Trillium Health Partners – Credit Valley Hospital

**Oncology Radiation Treatment Expansion
Cumulus Architects Inc. Project No.: 23010
WSP Project No.: CA0003678.3329**

ISSUED FOR ELECTRICAL ADDENDUM 1

February 4, 2026

GROUND FLOOR
LIGHTING NEW WORK

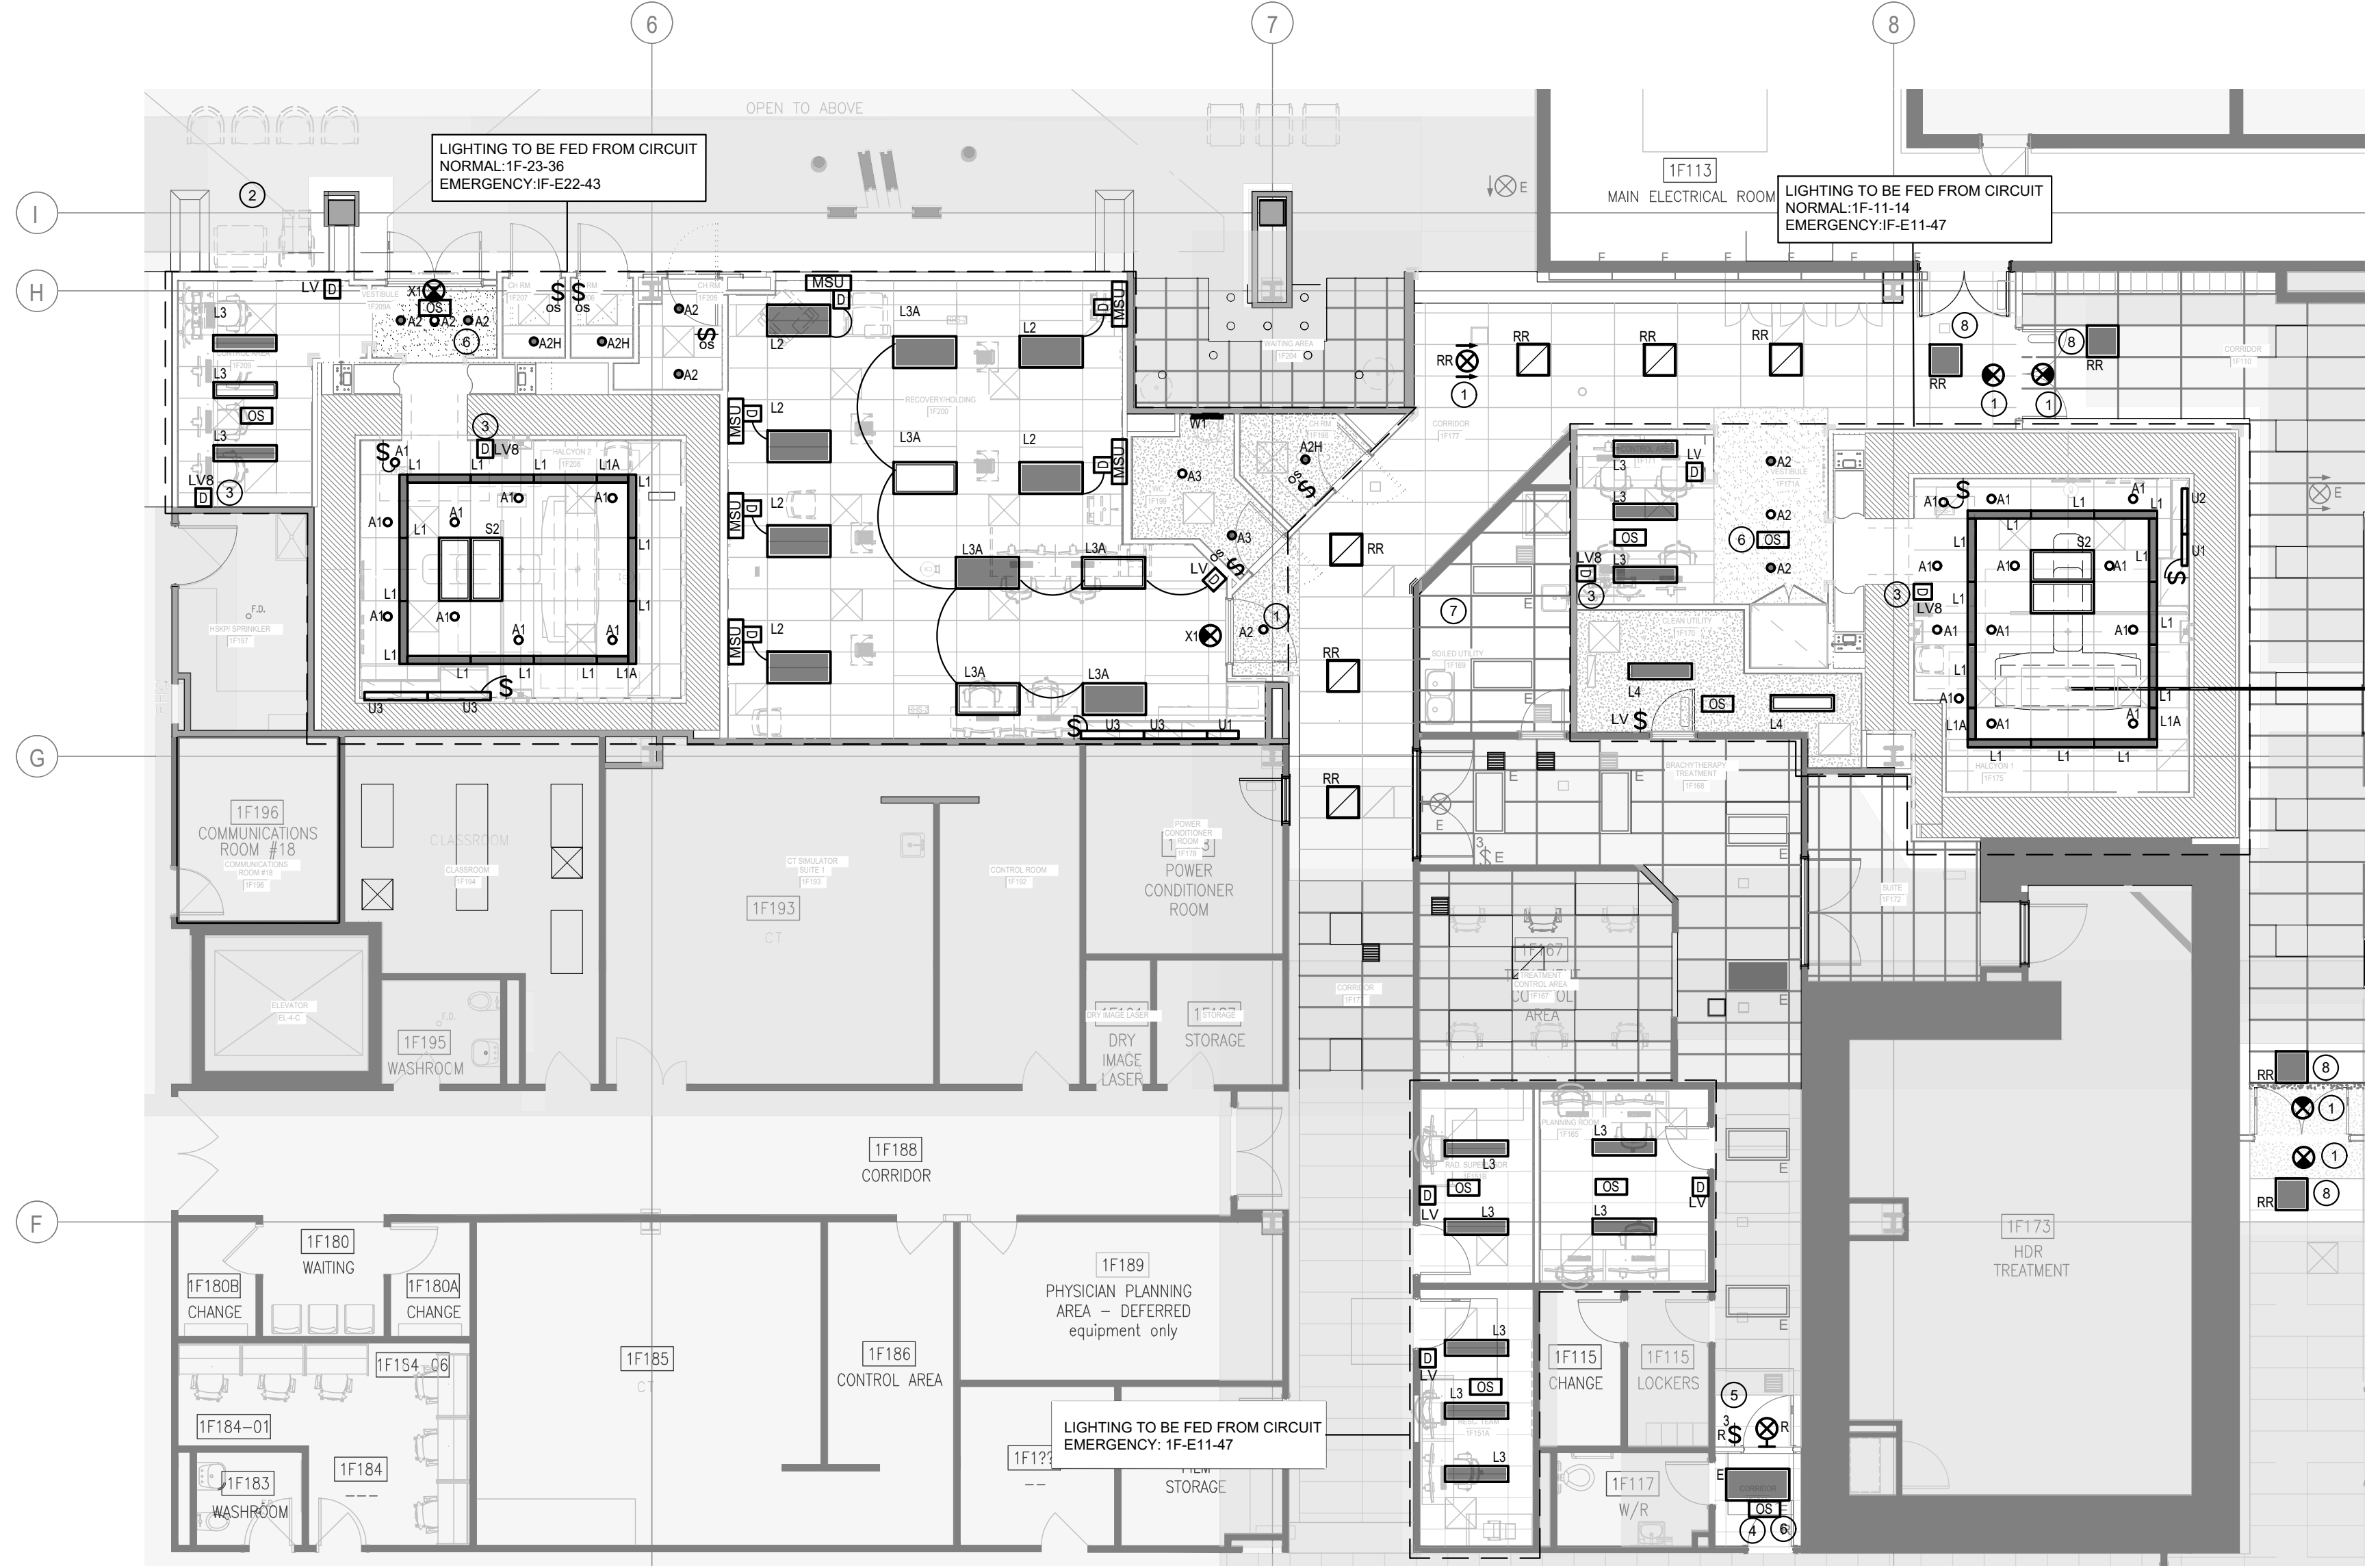
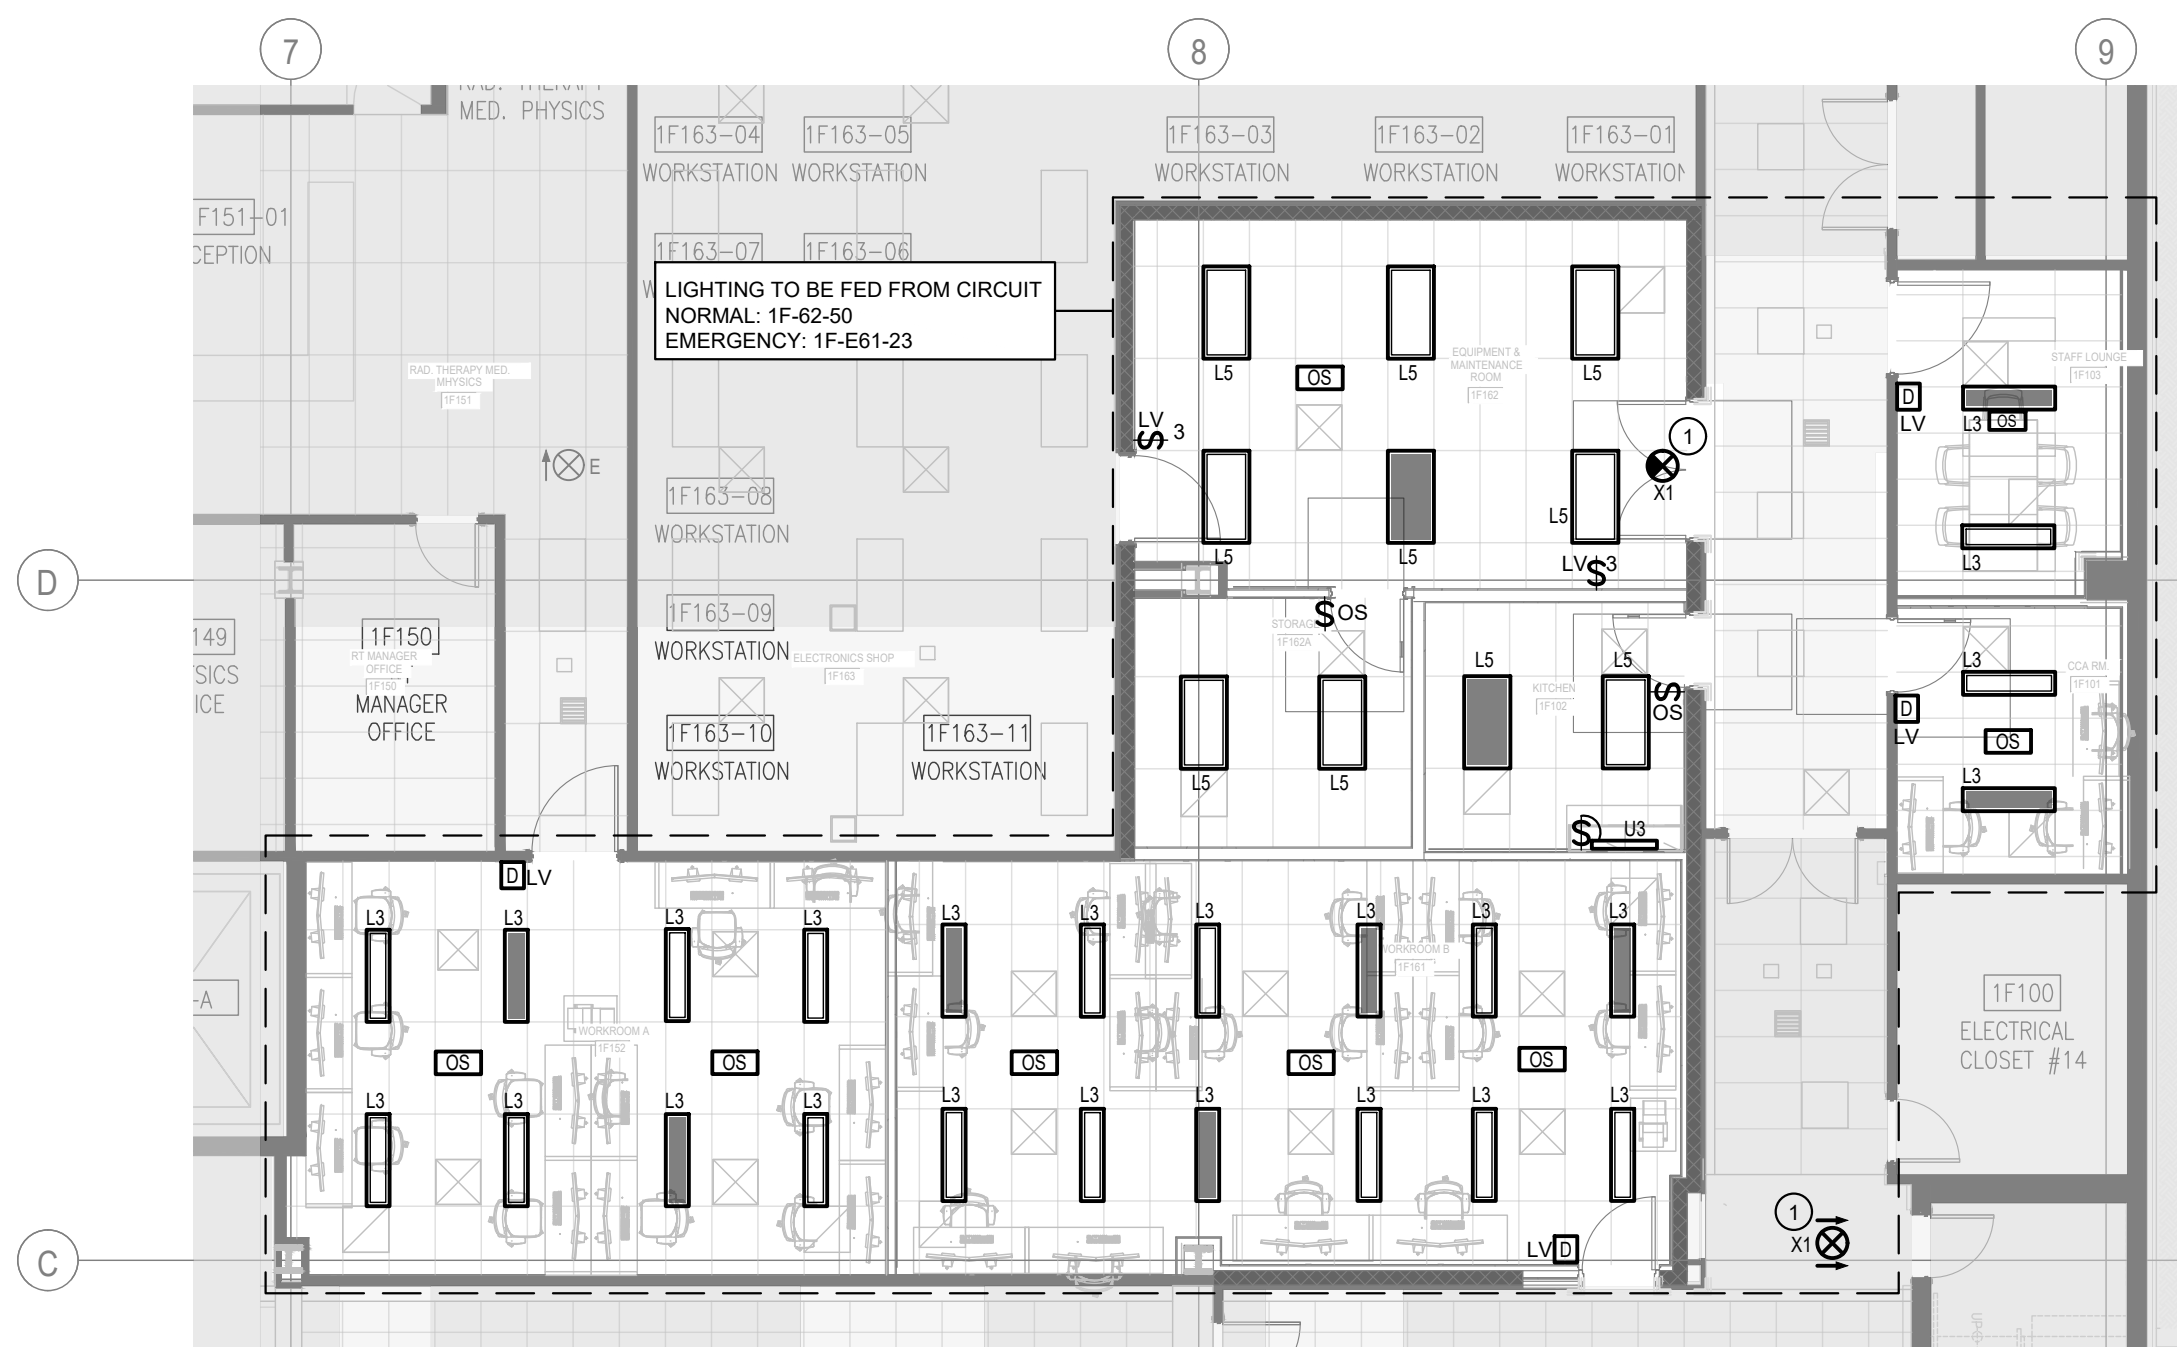
1.1 ELECTRICAL DRAWING E200

1.1.1 Revised note 3 referring to LV6 dimmer switch lighting zone controls.

- LIGHTING IN THIS AREA ARE EXISTING TO REMAIN.
- LIGHTING IN THE PROCEDURE ROOM TO BE CONTROLLED VIA TWO(2) 8-BUTTON WALL DIMMER SWITCHES, ONE LOCATED IN THE PROCEDURE ROOM AND THE OTHER IN THE ADJACENT CONTROL ROOM.
8-BUTTON DIMMER SWITCH TO CONTROL FOUR(4) LIGHTING ZONES. TWO BUTTONS FOR EACH ZONE TO RAISE AND LOWER THE LIGHTING LEVEL CONTINUOUSLY.
ZONE 1: 1 x 4 SURGICAL LUMINARIES
ZONE 2: GENERAL LIGHTING (DOWNLIGHTS)
ZONE 3: SKYLIGHT PANEL
ZONE 4: ALL LIGHTING IN ZONE 1, 2 AND 3

- ORTHOVOLTAGE LIGHTING CONTROL IN ROOM 1F126 TO MATCH THE ABOVE CONTROL SCHEME FOR ZONES 2, 3, AND 4 WITH A 6-BUTTON DIMMER SWITCH.
- DISCONNECT INDICATED FIXTURE FROM EXISTING LIGHTING CONTROL AND CONNECT TO NEW LOCAL OCCUPANCY SENSOR. MAINTAIN EXISTING CIRCUITING.

1 PART PLAN - GROUND FLOOR HALCYON #3 - FEEDER ROUTING - NEW WORKS
E506 1:100

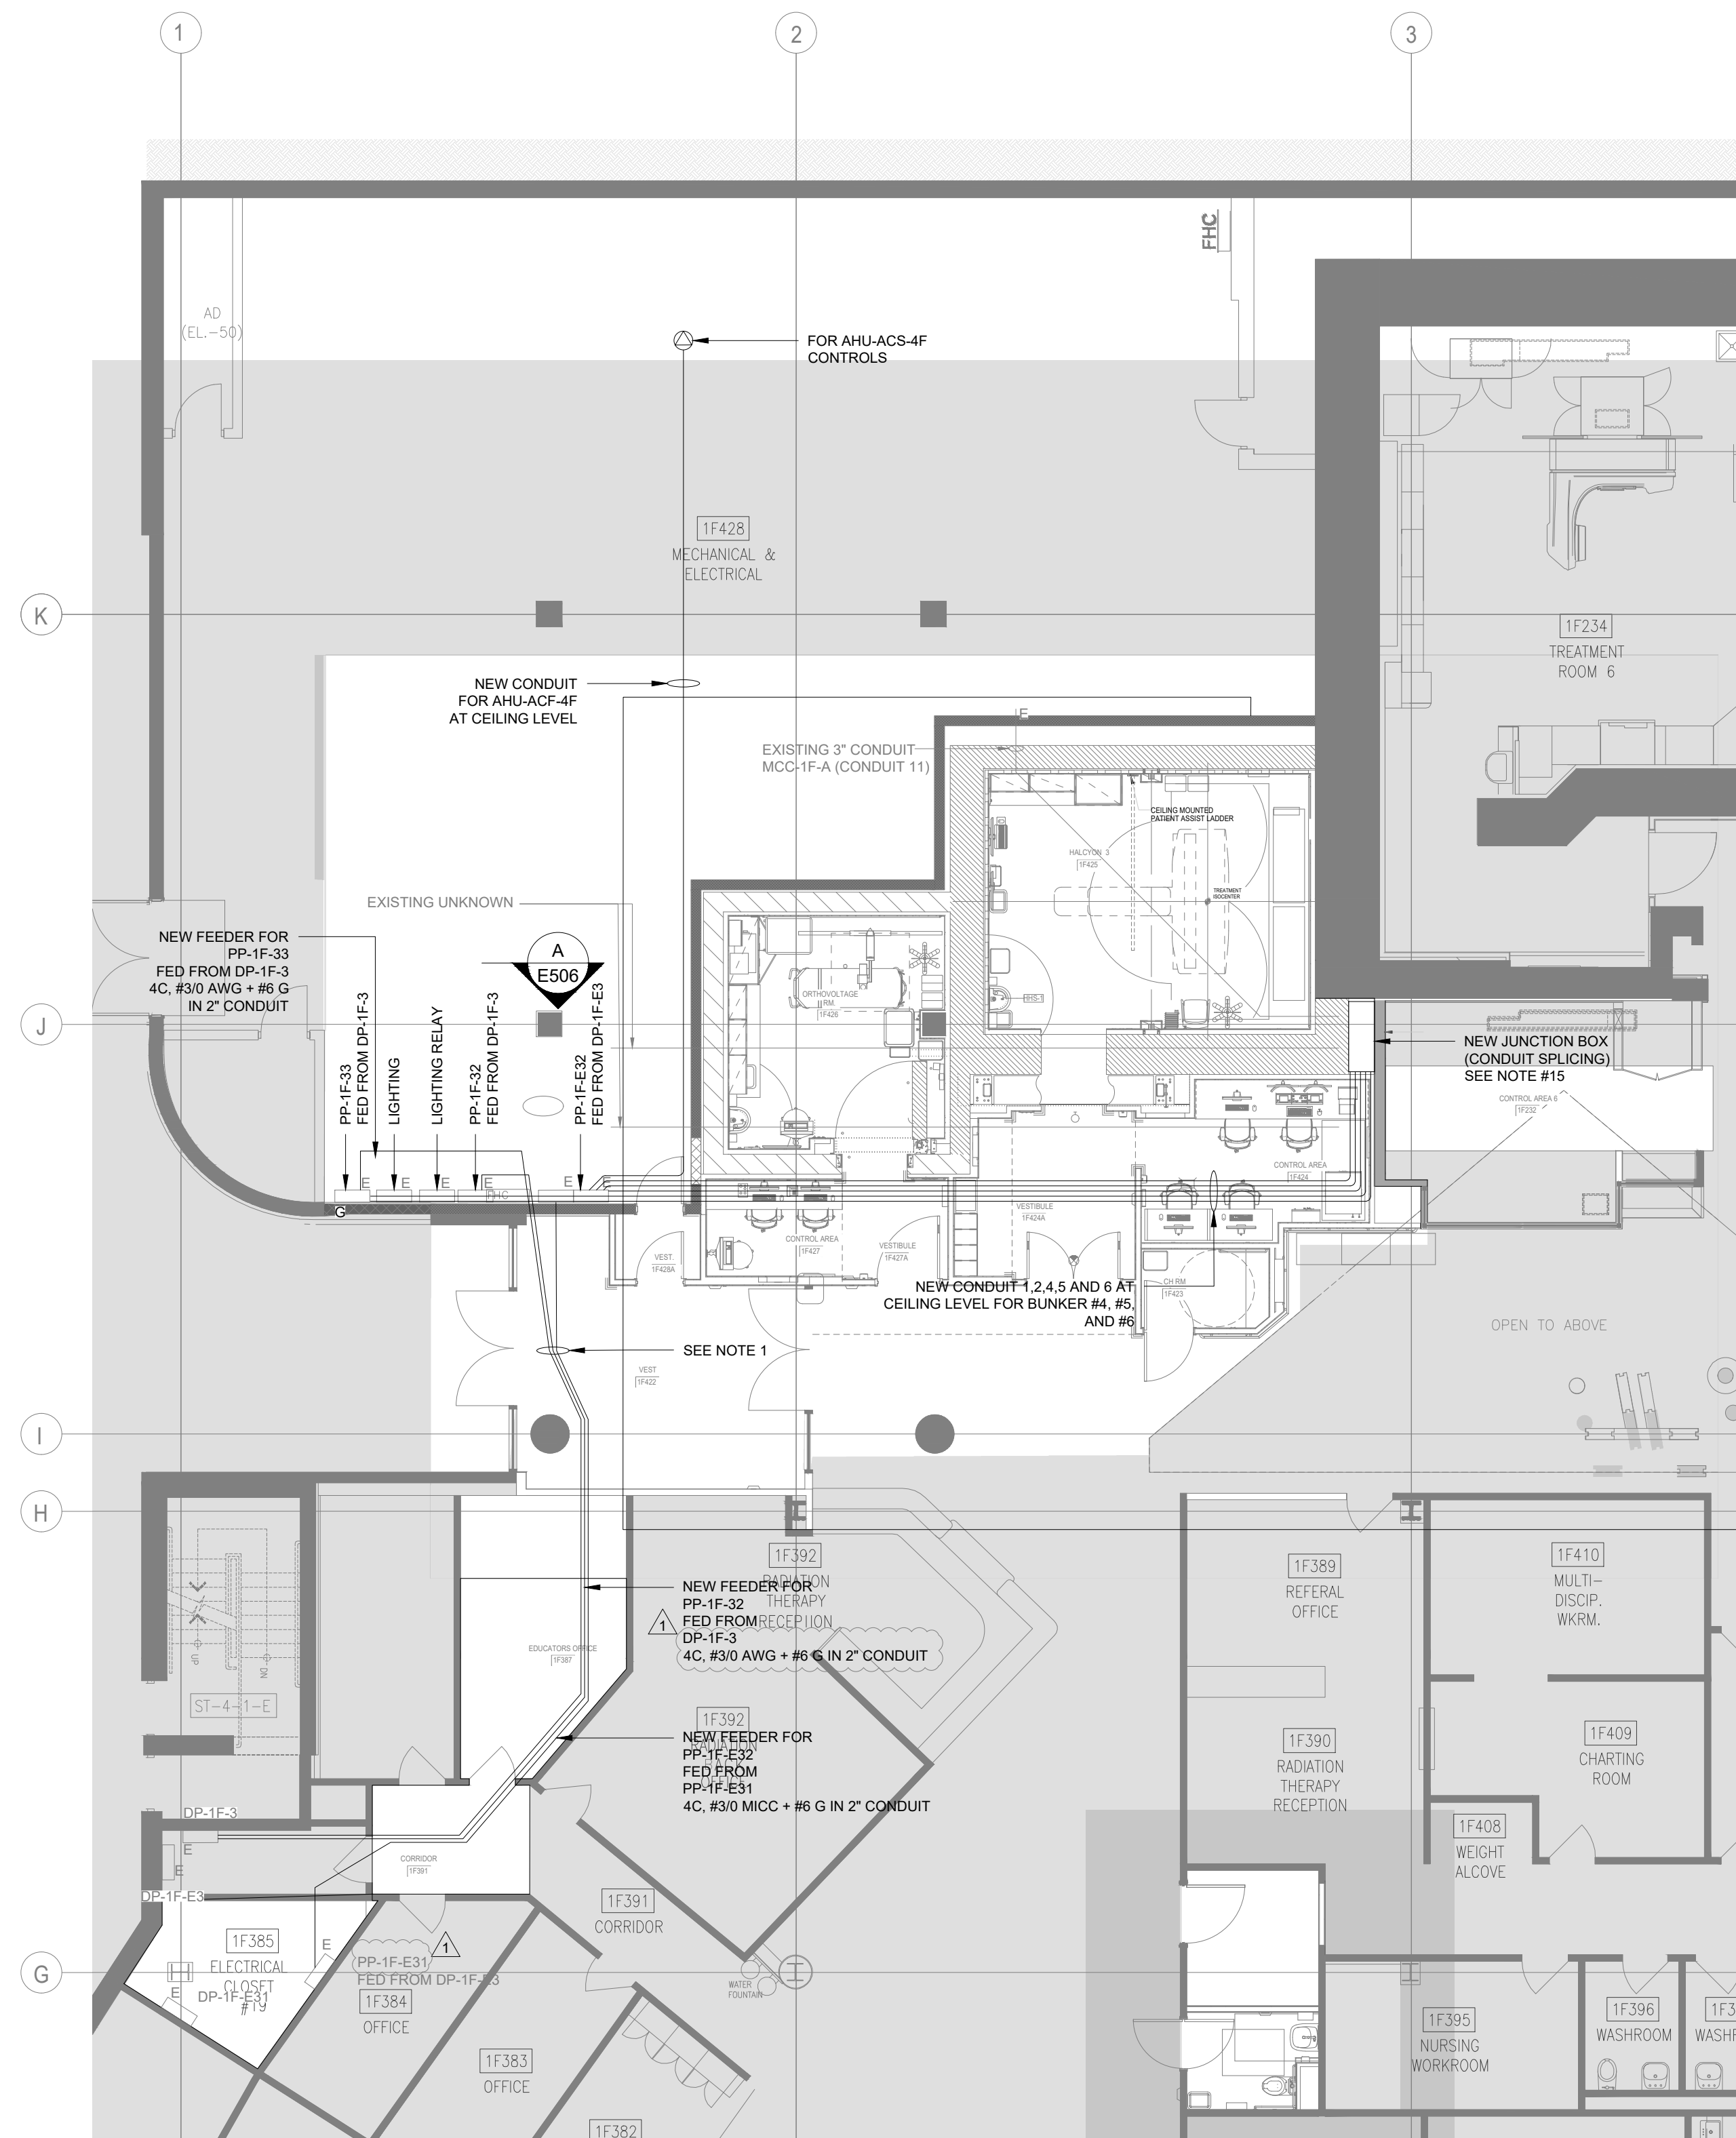
1.2.2 Detail 1, label for feeder to PP-1F-32 revised to remove MICC.

1.2.3 Detail 1, panel label in electrical closet 1F385 corrected to “PP-1F-E31” fed from DP-1F-E3.
